COMMONWEALTH OF VIRGINIA
COUNTY OF HENRICO

R. Joseph Emerson, Jr., AICP
Director of Planning
(804) 501-4602

RE: POD2021-00545
 Animal Hospital at Gateway Square
 Original Site Plan Review

GATEWAY SQUARE
THREE CHOP DISTRICT
HENRICO COUNTY, VIRGINIA

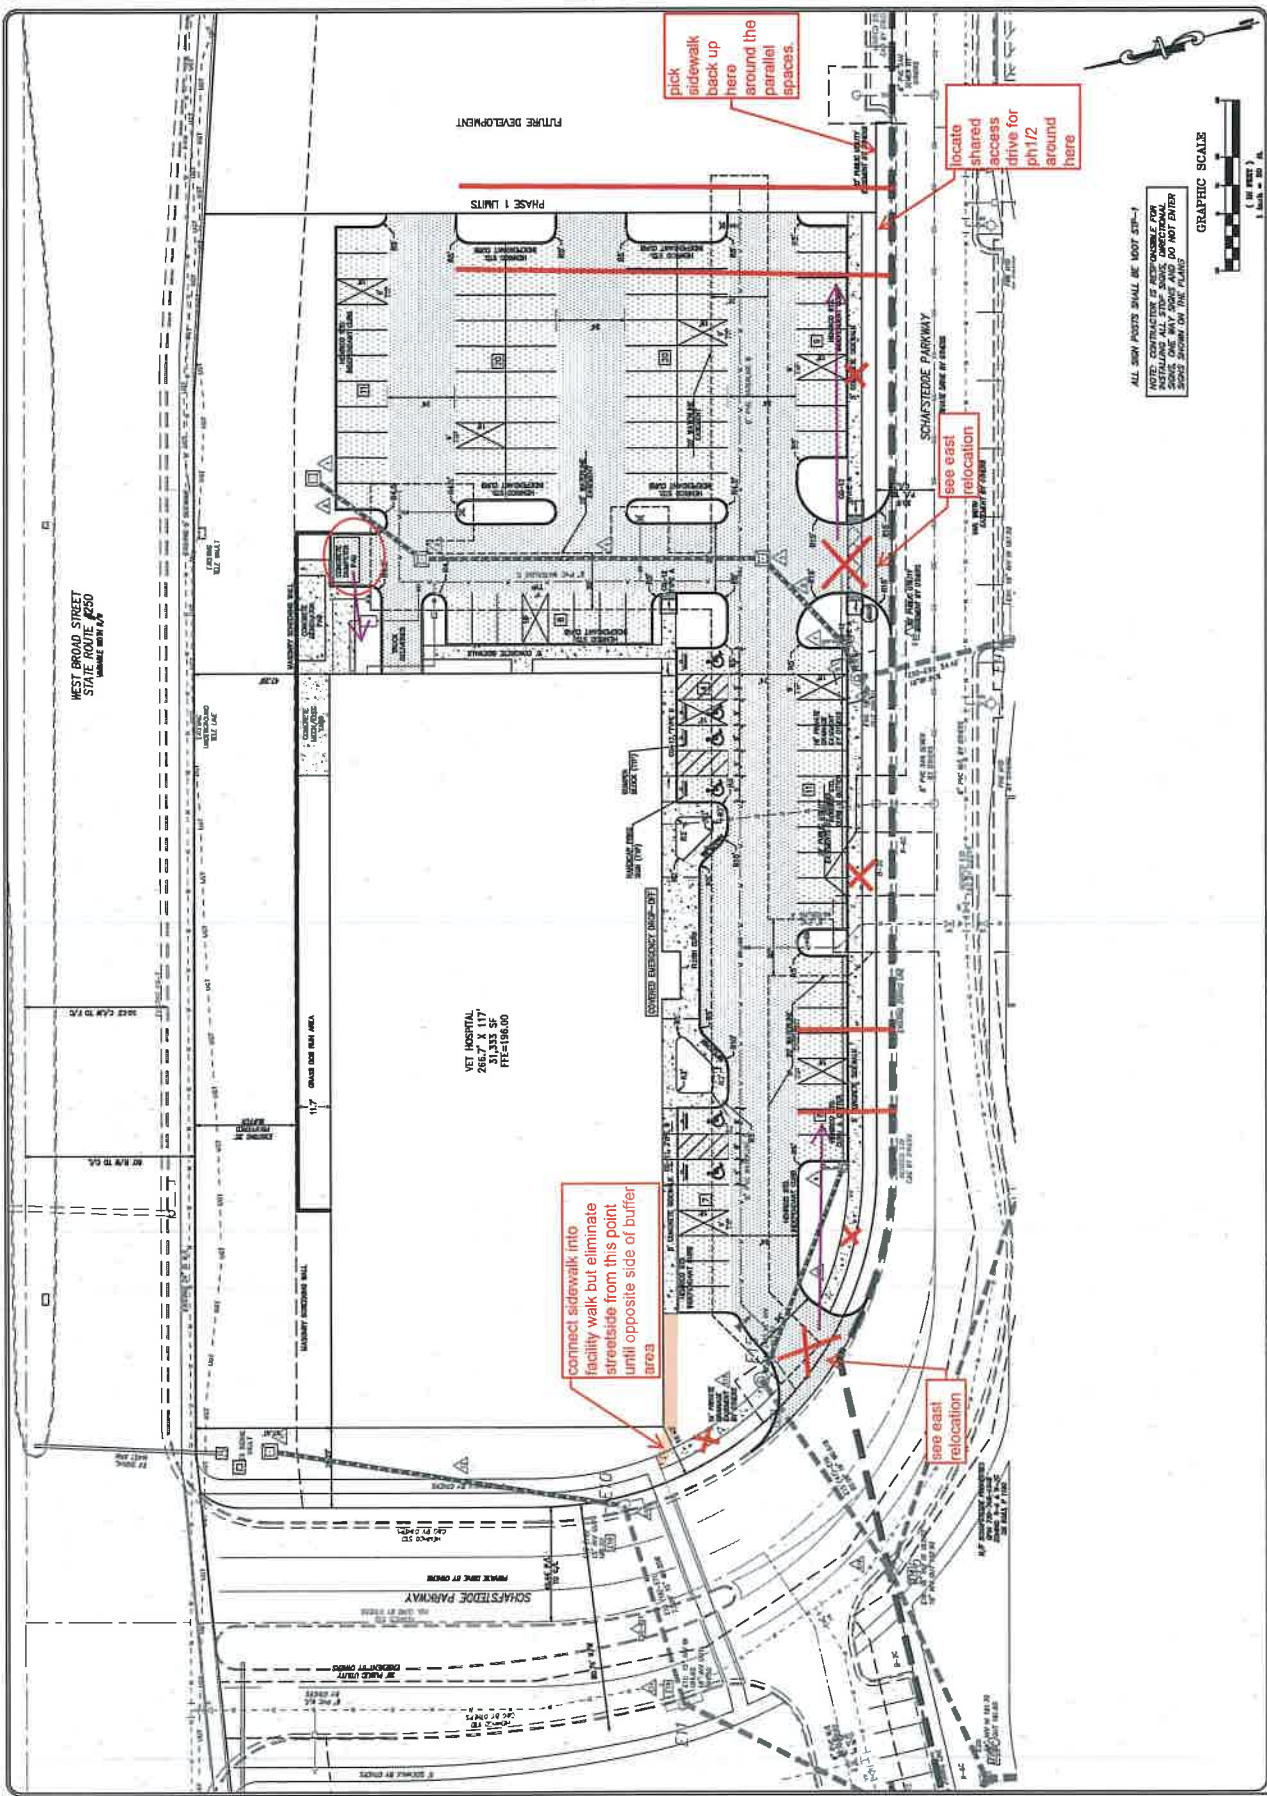
1. The layout does not correspond with the central placement of the building shown on the exhibit of PUP2021-00013. Many comments stem from this change, as follows:

- a. Provide a revised layout and conceptual landscape plan that addresses the landscape strip requirement in accordance with the exhibit a of provisional use permit PUP2021-00013. The current layout provides a direct view into a dumpster enclosure facing the residential town square. Evaluate relocation or rotating the dumpster to be located adjacent to the truck loading space with the opening facing eastward.

- b. The PUP exhibit provided devoted landscape buffer width and routed the sidewalk away from this portion of the private street frontage. The proposed layout absorbs half of the TB25 plant area for the sidewalk.

- c. The location of the western entrance misaligns with the approved condominium entrance to the southwest and is close to the pedestrian crossing, creating safety concerns.

- d. The entrance placement also introduces sight line conflicts among the required TB 25 buffer landscaping that would not have been an issue had the layout followed the PUP exhibit.
